Access Compliance Report

Public Rights-of-Way

(Curb Ramps)

Intersection ID: 45182	Main Street: MAPLEHURST_DR	Cross Street: SOCIETY_ST	Location: SW
ADA ID: 20D534E7C470	Ramp Type: BlendTrans2	Initial Pass/Fail: Fail	Overall Compliance: No
Severity Score: 8.75			
Codes/Mitigation Info/Possible Solution		Field Measurements/Component Compliance

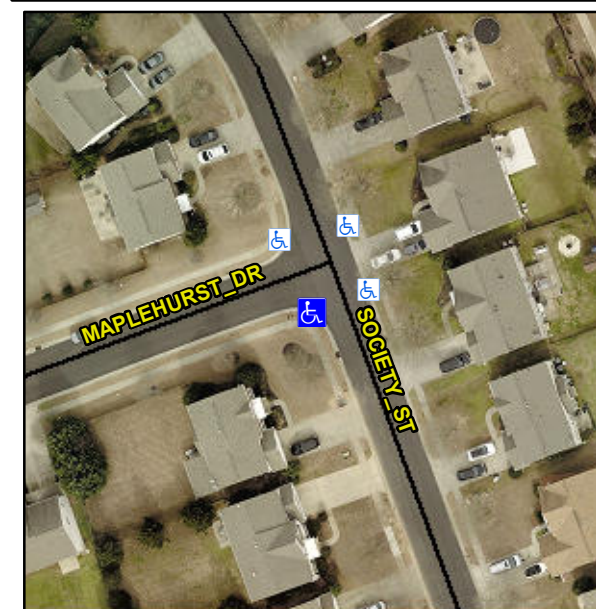
Not Found, R304.5.1

Compliance	Description	Data	Compliance	Description	Data
N/A	Ramp Length (in)	94.0	Yes	BlendTrans Slope (%)	1.2
No	Ramp Width (in)	46.0	Yes	BlendTrans XSlope (%)	1.0
N/A	Flare Type LT	N/A	N/A	Flare Type RT	N/A
N/A	Flare Slope LT (%)	N/A	N/A	Flare Slope RT (%)	N/A
N/A	Flare Traversable LT?	N/A	N/A	Flare Traversable RT?	N/A
N/A	Landing Length (in)	N/A	N/A	DWS Provided?	N/A
N/A	Landing Width (in)	N/A	N/A	DWS Contrast?	N/A
N/A	Landing Slope (%)	N/A	N/A	DWS Length (in)	N/A
N/A	Landing X Slope (%)	N/A	N/A	DWS Full Width?	N/A
N/A	Landing Curb? (Y/N)	N/A	N/A	DWS Offset (in)	N/A
N/A	Shared Landing?	N/A			
N/A	Gutter Ponding?	N/A	N/A	Gutter Slope (%)	N/A
N/A	Gutter Lip Ht (in)	N/A	N/A	Gutter X Slope (%)	N/A
N/A	Painted X Walk1?	No	N/A	Painted X Walk2?	No
	X Walk 1 Direction	To NE		X Walk 2 Direction	To NW
	X Walk 1 Width (in)	N/A		X Walk 2 Width (in)	N/A
	X Walk 1 Slope (%)	2.1		X Walk 2 Slope (%)	0.7
	X Walk 1 X Slope (%)	1.1		X Walk 2 X Slope (%)	2.4

N/A	Ramp inside XWalk1?	N/A	N/A	Ramp inside XWalk2?	N/A
	Road Slope (%)	0.1		Clear Space?	N/A
	Road X Slope (%)	2.0	N/A	Clear Space to XWalk (in)	N/A
N/A	Any Obstructions?	N/A	N/A	Storm Grate/Utility Hazard?	N/A
	Obstruction Type			Storm Grate/Utility Type	
		N/A			N/A
			Yes	Surface Condition? (G/P)	Good
			No	Curb Slope (%)	7.9

Remove & Replace Curb Ramp With Two New Directional Ramps or Equivalent.
